**Date:** July 14, 1992

**Subject:** Feedback on "PA Modeling Using BRAGFLO -- 1992" 7-8-92 memo by J. Schreiber

PA Modeling Using BRAGFLO -- 1992

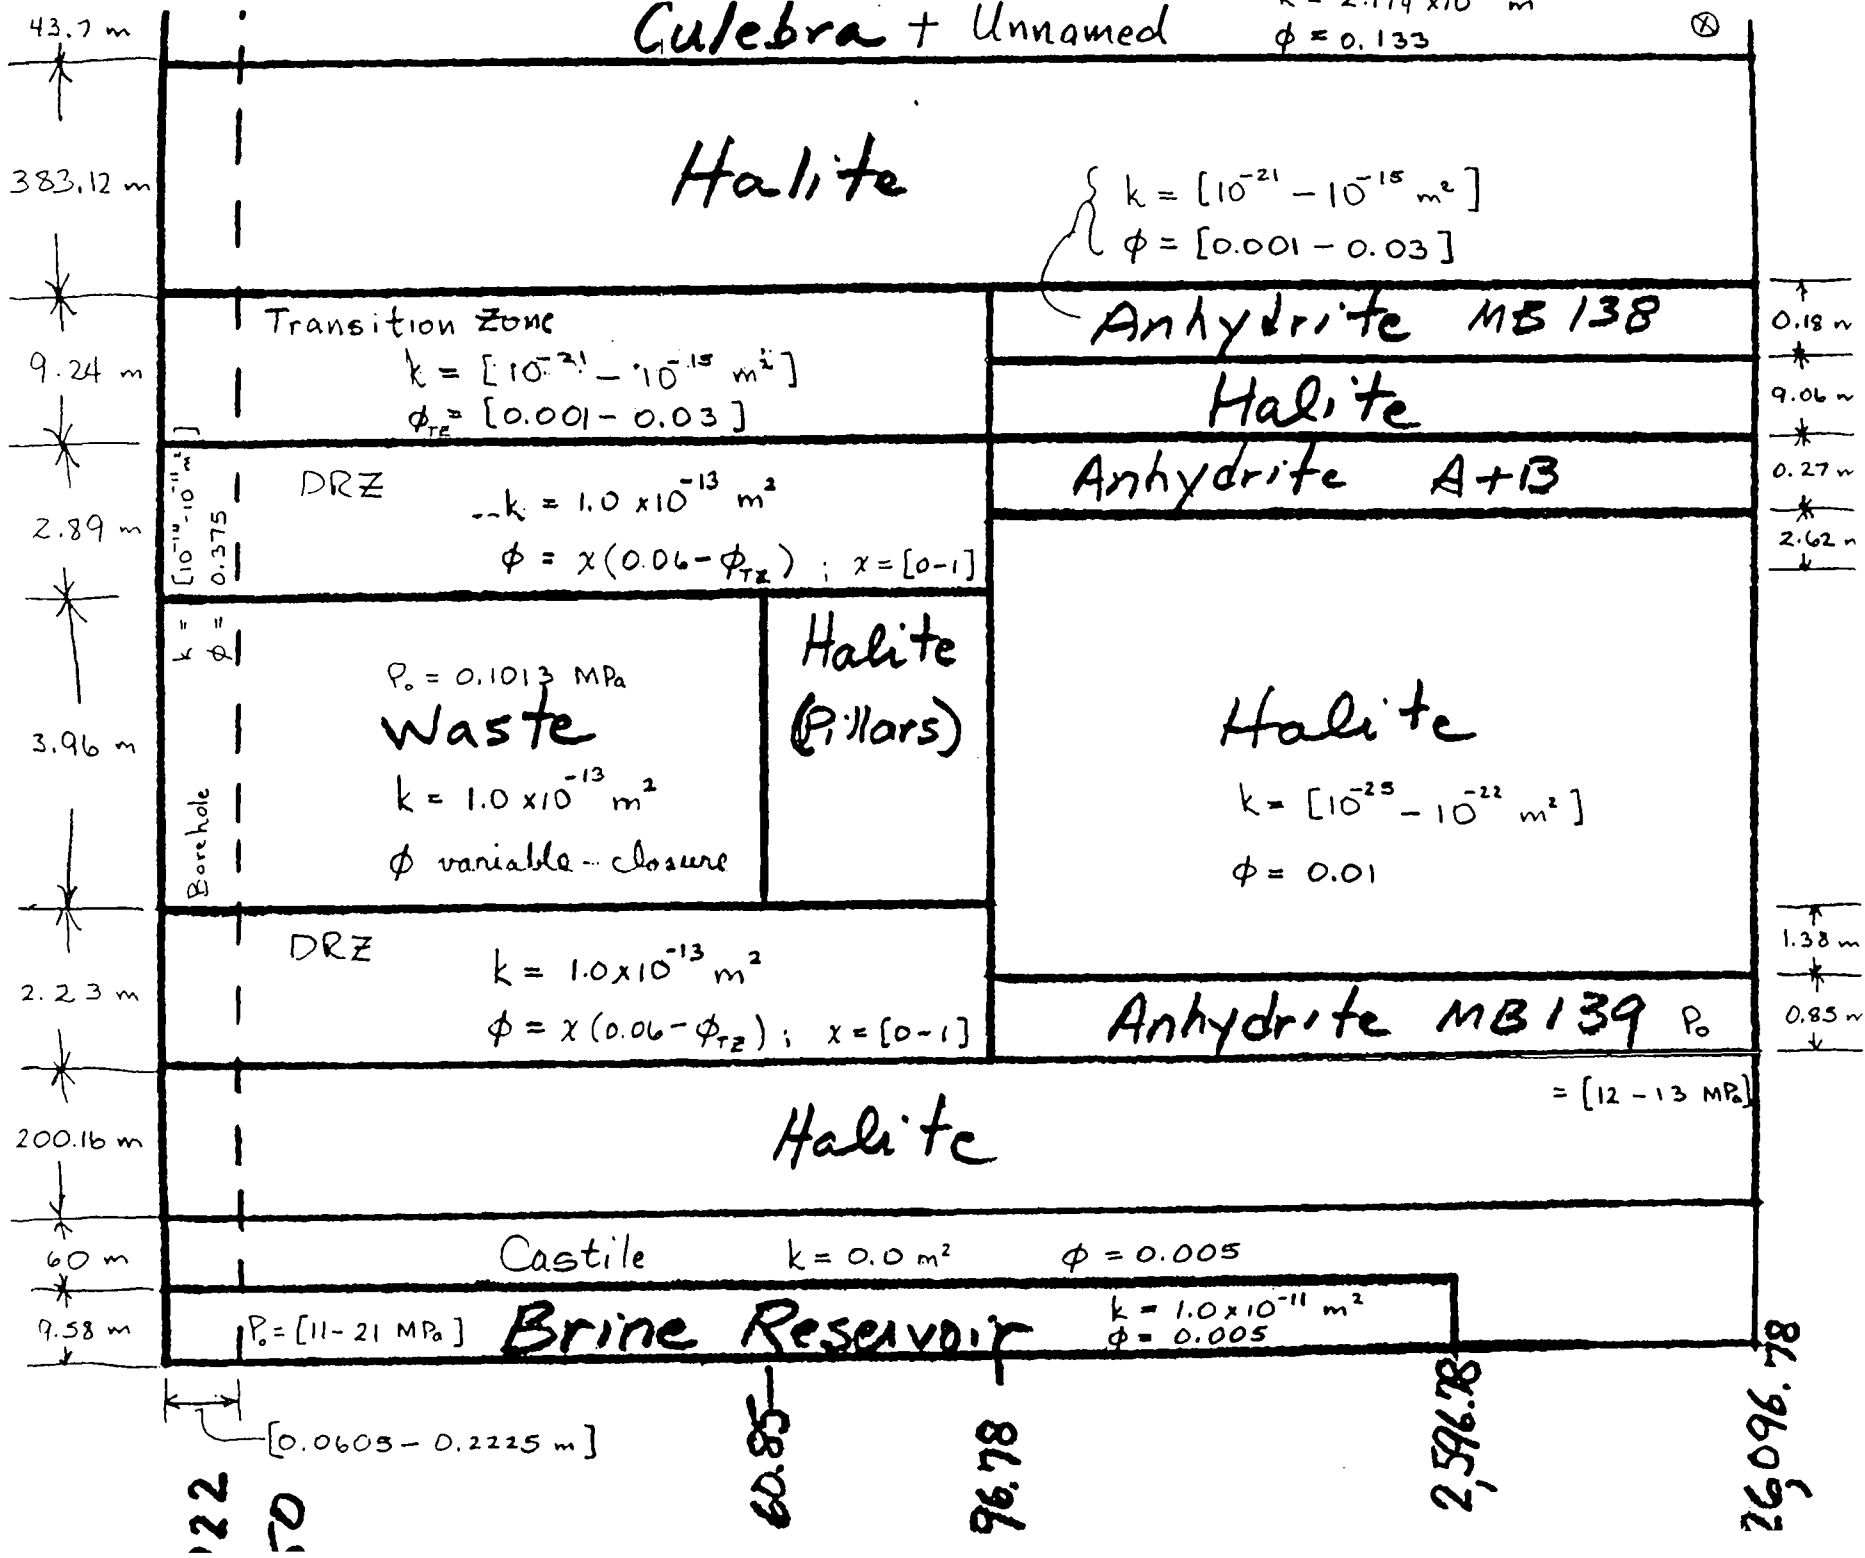
2. The illustration of the model configuration is somewhat confusing in that it gives the appearance that the anhydrite interbeds start at the lateral edge of the DRZ and transition zones. Perhaps these schematics would benefit by showing how the geologic units fit into the model zones.

1992 Undisturbed Anhydrite Permeability

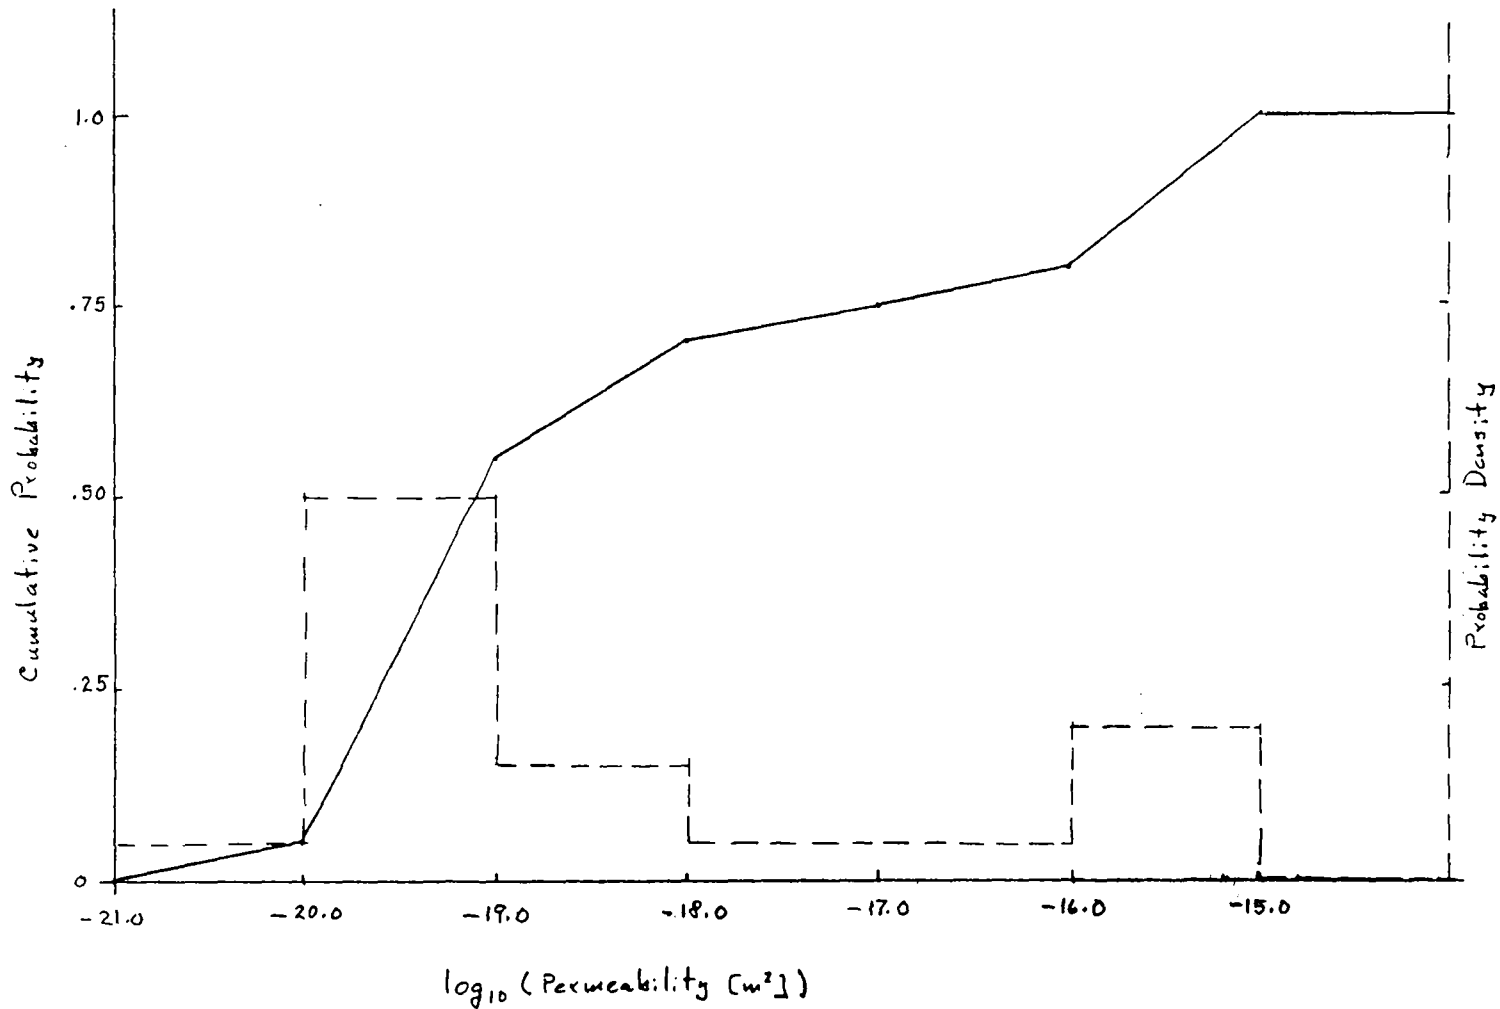
6. We (6119 and 6342) have not yet reached good closure on the question of the far field permeability distribution for the anhydrite interbeds. The original recommendation (model configuration and parameter distributions transmitted to PA 4-1-92 by E.D. Gorham) was to use only permeability values from a limited number of tests (3) in non-depressurized anhydrite. This approach assumed that the PA model for the 1992 calculations would be capable of including increased permeability due to fracture dilatation in response to elevated gas pressures. When it became apparent that fracture-based permeability changes will not be available in the '92 models, it was recommended that an attempt be made to crudely incorporate the effects of gas-driven increases in fracture permeability by specifying a much larger far-field permeability range for the anhydrite that included not only the non-depressurized tests, but also the group of tests in depressurized but substantially intact anhydrite and the group of tests in anhydrite that has experienced substantial fracturing in the DRZ (E.D. Gorham 6-15-92 memo). This approach was considered unrealistically conservative by performance assessment personnel in the June 25th meeting and a compromise was reached that 1) the performance assessment calculations will not attempt any representation of the interbed fracture process in the '92 calculations; 2) that explicit caveats will be placed visibly in the report that this potentially significant process was not included in the calculations; and 3) the field permeability for the anhydrite interbeds will be represented by the small group of tests in non-

depressurized anhydrite interbeds together with the much larger group of tests in depressurized but substantially intact anhydrite. While this compromise appears to be acceptable to most people, it should be recognized that this distribution is not without potential flaws that could perhaps be corrected if there were sufficient time to construct a new distribution that focused on capturing the uncertainty in whether or not some of the tests in the depressurized but substantially intact anhydrite have in fact experienced significant permeability enhancing deformation. Given the present time constraints, we suggest that the compromise distribution be used, but that it be recognized that this distribution is not without potentially important flaws.
